**Mixing Analysis for the Port of Corpus Christi Authority of Nueces County
TPDES Permit No. WQ0005253000**

**Reviewed by Katie Cunningham
August 10, 2021**

Figure 1: Proposed Diffuser Location from Revised Application

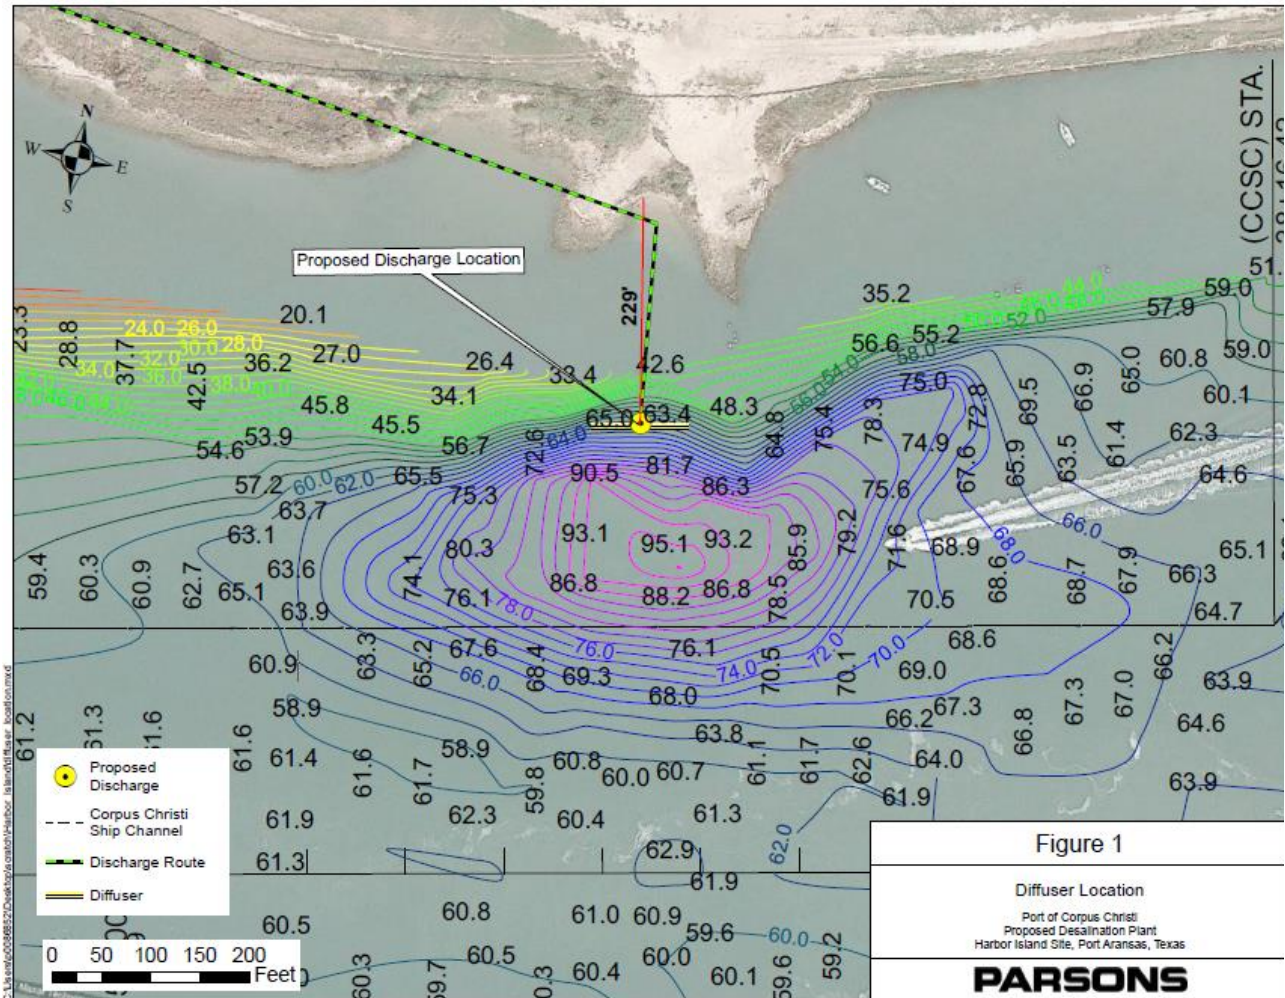
In the original application, the proposed diffuser was planned to be located approximately 300 feet from the shoreline. However, the amended application indicates that the proposed diffuser will be approximately 229 feet from the shoreline and will be located on the north slope of an eddy-generated “hole” in the channel. At the revised diffuser location, the applicant’s diffuser report indicates that the local depth of the water body is 27.4 meters (90 feet). Figure 1 is from the amended application, and where the diffuser is proposed, the bathymetry map indicates the depth of the water body is approximately 20 meters (65 feet). However, the applicant later clarified that because the diffuser is located on a steeply sloping side of the channel and because the ports discharge at an angle of 30 degrees to the horizontal and point across the channel toward the opposite bank, the resulting depth of the channel at which the effluent discharges into is approximately 90 feet.
